RELAS AD6 Stage 7 Common Submission

Version 1.0 - 27 August 2024

1.3 Key Reasons Not To Approve AD6

Figure 6 LLA Arrivals to Runway 25 descending from 12,000ft-8,000ft showing ZAGZO hold (north), 7 days in June 2023 post-airspace change

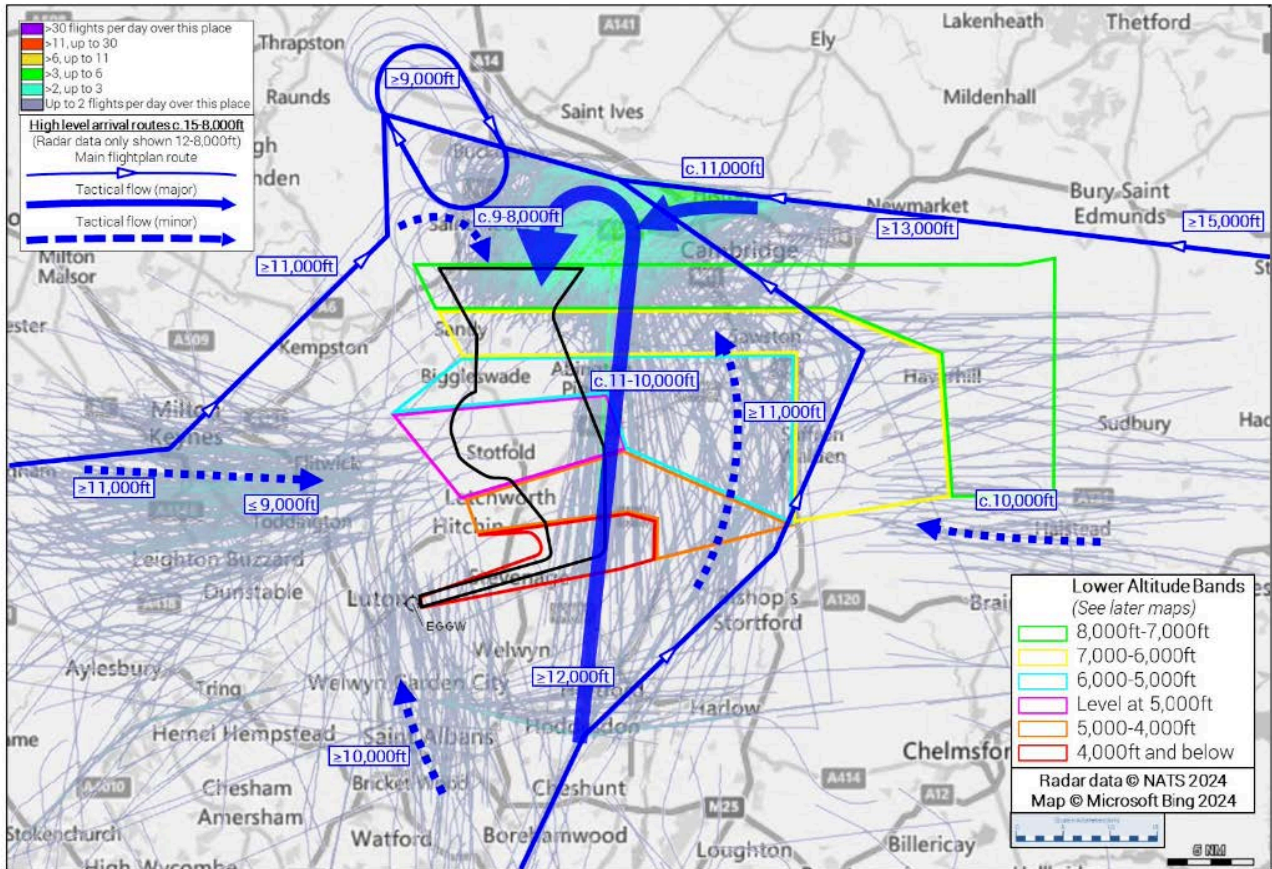
The Tactical Flow diagram in CAP1616 AD6 Stage 7 Post-Implementation Review Annex A, reproduced below, provides the NATS/LLA interpretation of the actual traffic distribution flow. This is substantially different from the AD6 expectation outlined in the previous section, as will be explained in more detail:

The 7 day sample period selected by NATS as 'representative' used in the previous diagram does illustrate the issues described in this report, but is not fully representative of flights over a longer summer reporting period.

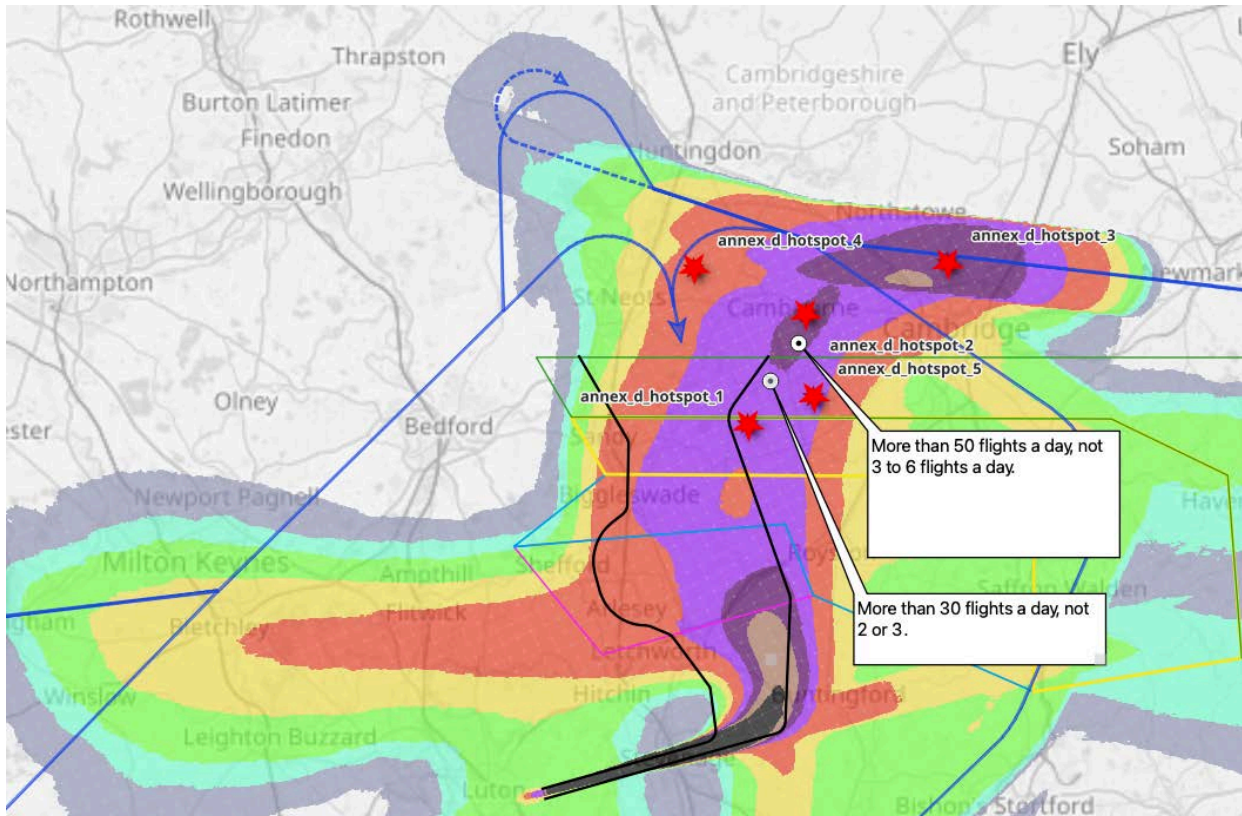
In detail, the number of overflights is plotted using the exact CAP1498 'inverted cone' methodology, over a 100m grid, but we have extended the height to 12,000 ft for direct comparison with the overflight data in the earlier NATS/LLA diagram.

As can be seen from the diagram many areas in South Cambridge have over 50 flights a day³, while the PIR Tactical Flow diagram shows at most 6 per day across this area. Interestingly, the **count of at least 50 flights per day is consistent with the estimate modelled in the PIR Noise Report (Fig 35)**

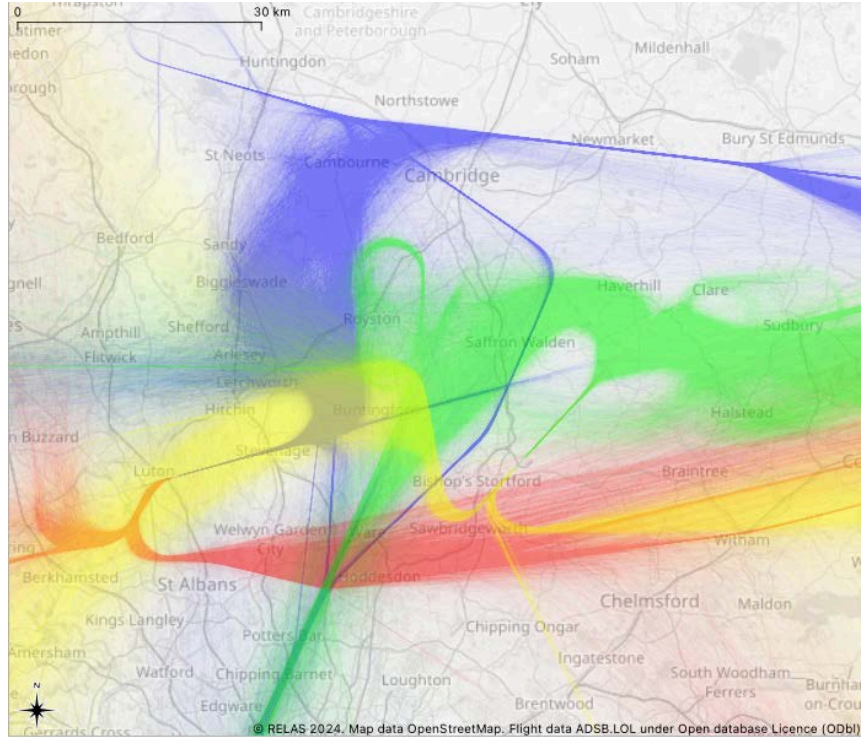
The restriction on Luton only operating CDO below 5,000ft rather than from top of descent due to airspace conflicts is no longer valid, especially for aircraft arriving from the east.

This restriction on CDO only being in operation below 5,000 ft should be removed⁵. Aircraft arriving at Luton should be required to fly CDO from ToD, and report CDO on at least the same basis as other London airports.

No explanation has ever been given why the Luton arrivals marked in blue can not operate CDO from ToD, especially early in the morning (e.g. 6:30 to 8am overflight of West Cambridge).

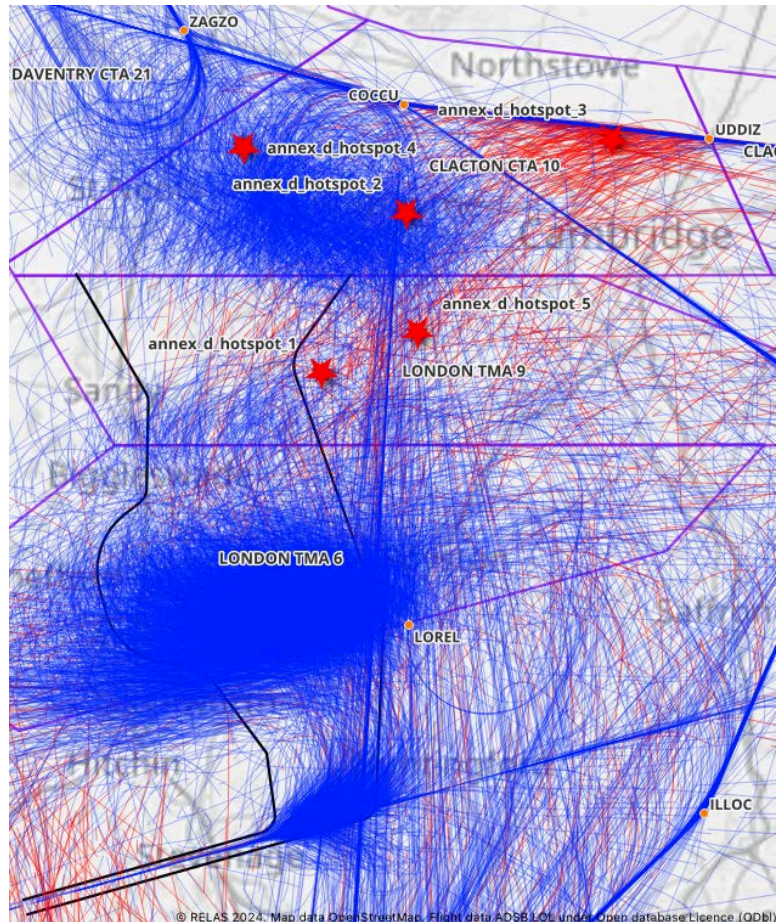
Ideally, aircraft should descend smoothly at a 3-degree angle (CDO). However, the chart reveals stepped descents with steep drops (red lines show >2500 ft/min, ~5.6degrees) and long level flight periods (blue lines show <250 ft/min). Complaint hotspots are shown by red stars.

Stepped descents cause increased noise due to increased engine thrust and abnormal recognisable and intrusive pitch patterns. This approach is less efficient in terms of CO2 emissions and noise reduction.

A significant portion of these flights are in peak periods (06:45 to 8:00 am), even when there's little conflicting air traffic which might justify this non-optimal approach. A contributing factor is the sudden change in minimum height from 11,000ft to 8,000ft after UDDIZ, as aircraft attempt to shortcut across CLACTON CTA 10 airspace.

Figure 11 Option 1 for Westerly Runway 25 – Vectoring and Shortcuts

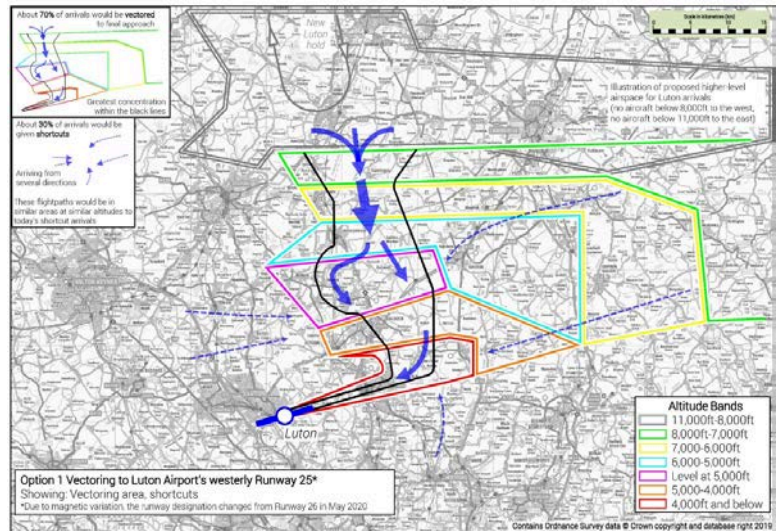
The key on the consultation diagram (reproduced on the right) states 'Altitude', i.e. feet above sea level.

However, Luton has rejected most complaints about height relating to coloured bands above 5,000 ft with reasons including:

2. Lack of clarity whether the on the consultation diagram should be interpreted as flight levels or altitudes.
3. Leveraging the fact that the Luton Travis noise reporting system labels all aircraft as having a non-specific 'height', and adding un-verifiable height calculations in written responses. Luton refuses to accept complaints from 3rd party systems that might provide both flight level and altitude.
